CITY OF ALBUQUERQUE

Re: Universe Street Capacity Analysis ~~X~~
Engineer's Stamp Date 2/14/13 (C09/D001B)

Job Name: Trails Universe Storm Drain

Re: Universe Storm Drain – City Project # 761283

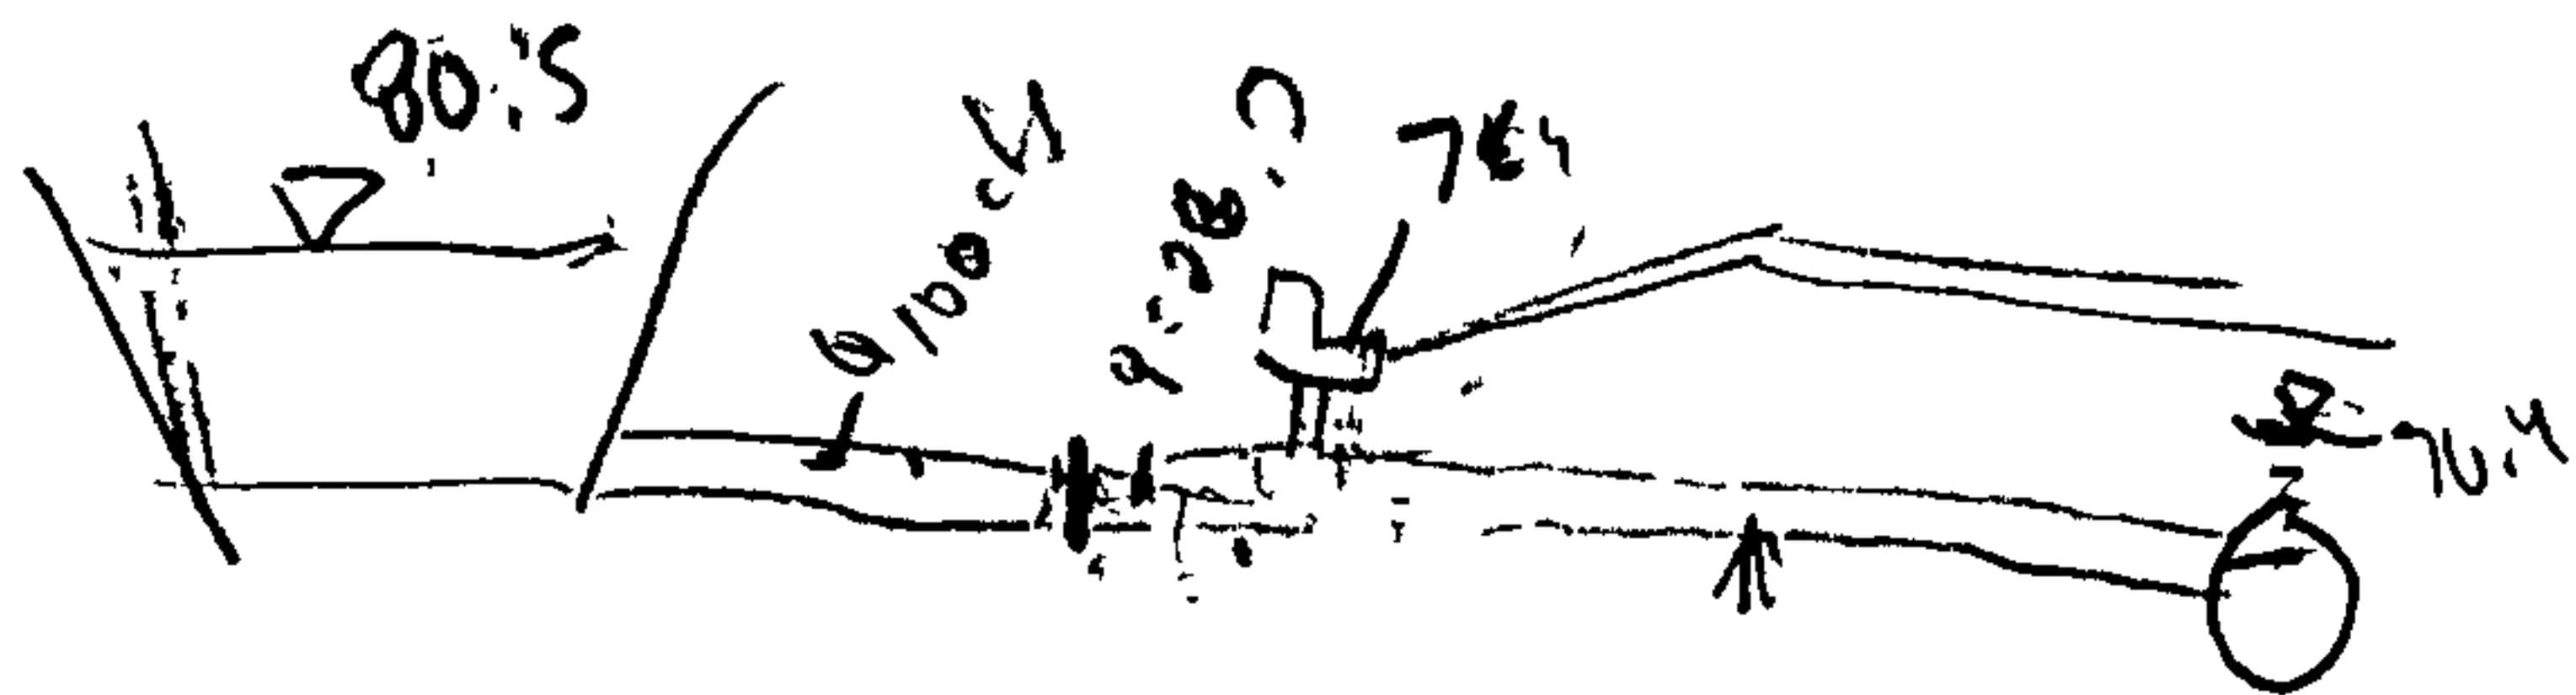
> 29 cfs ok

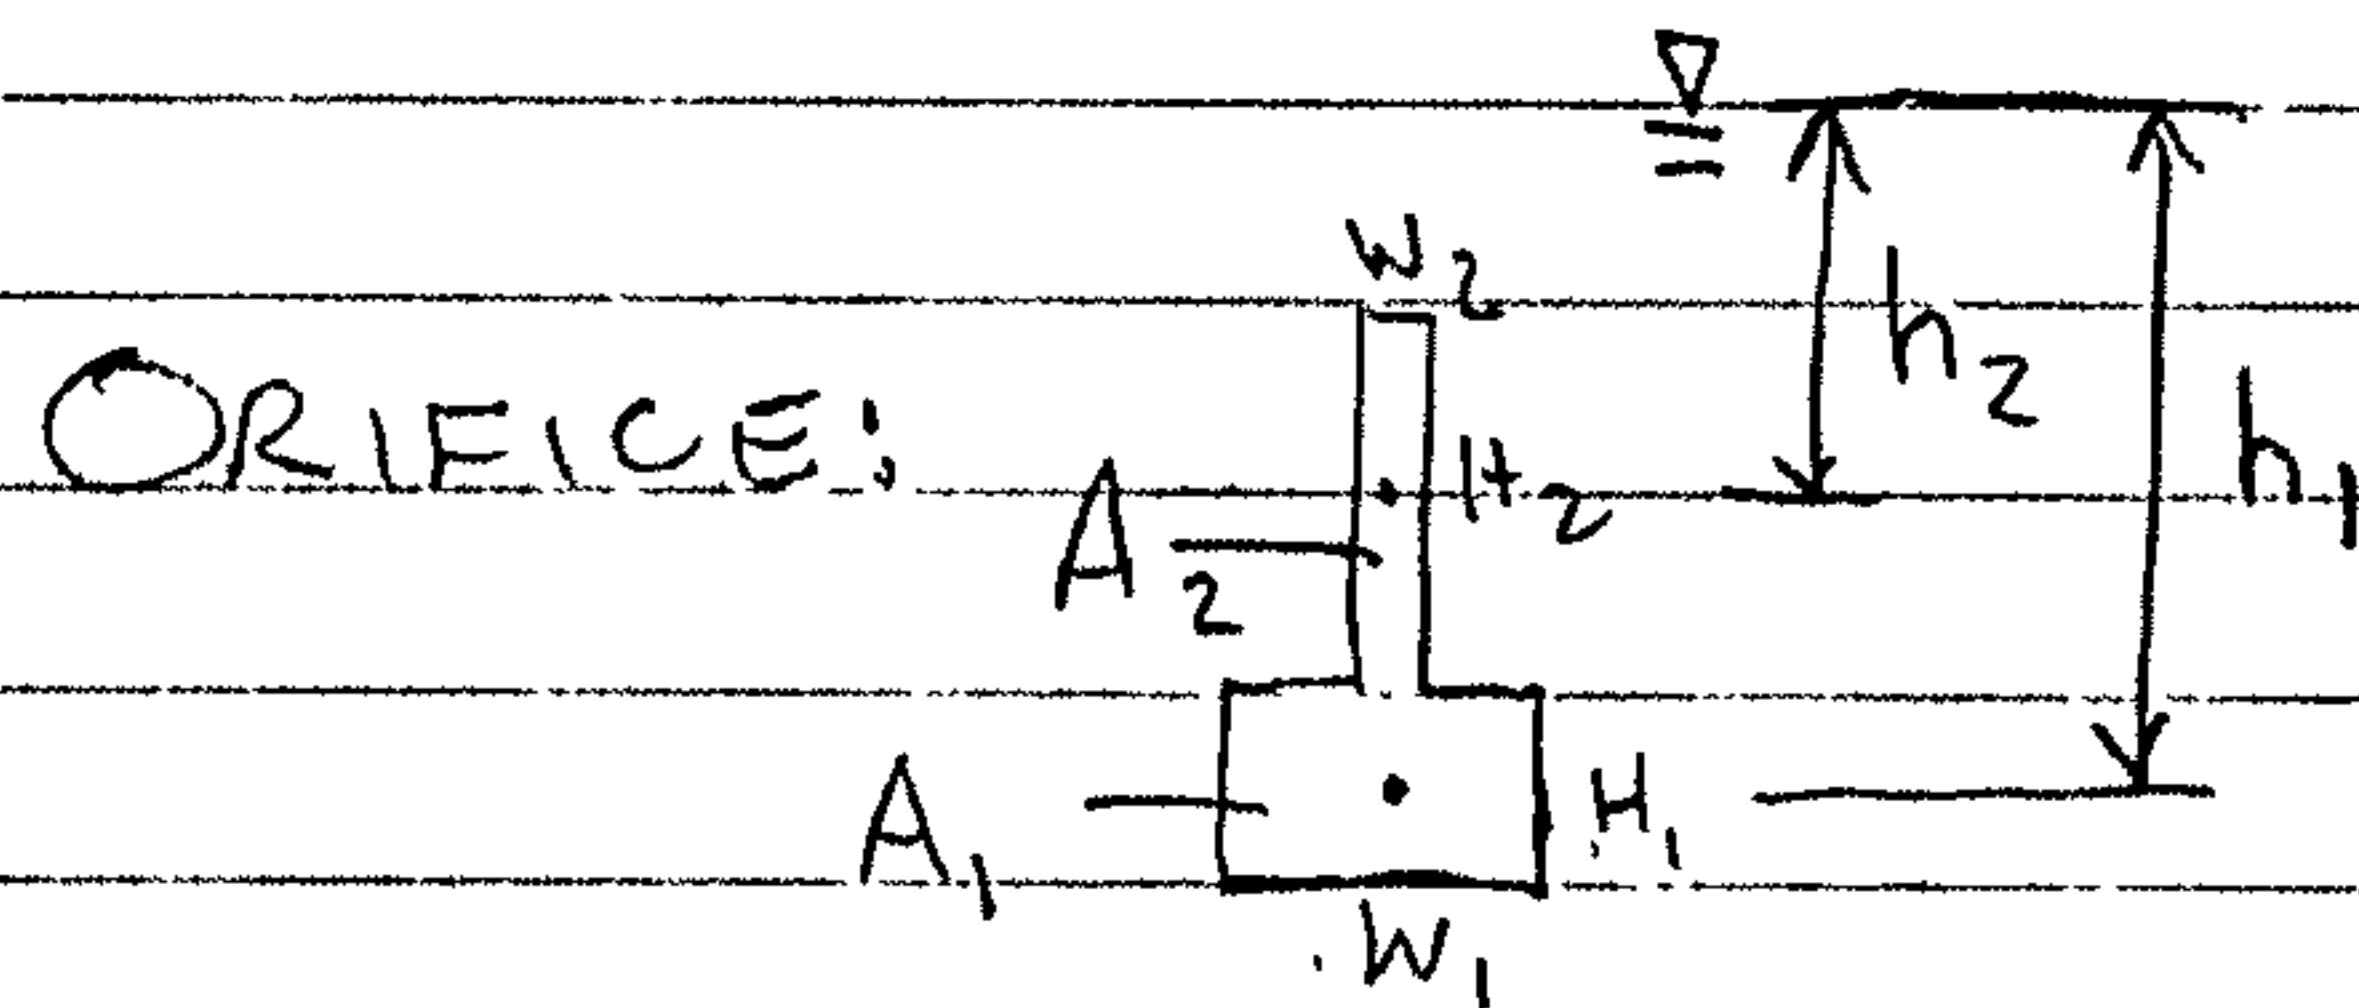
APS Flowrate	Manhole #1	Manhole #2	Manhole #3
(cfs)	Surge (ft)	Surge (ft)	Surge (ft)
4.5	0		
5	0.18		
6	0.62		
7	1.08		
8	1.54	0.10	0.31
9	2.00	0.40	0.87
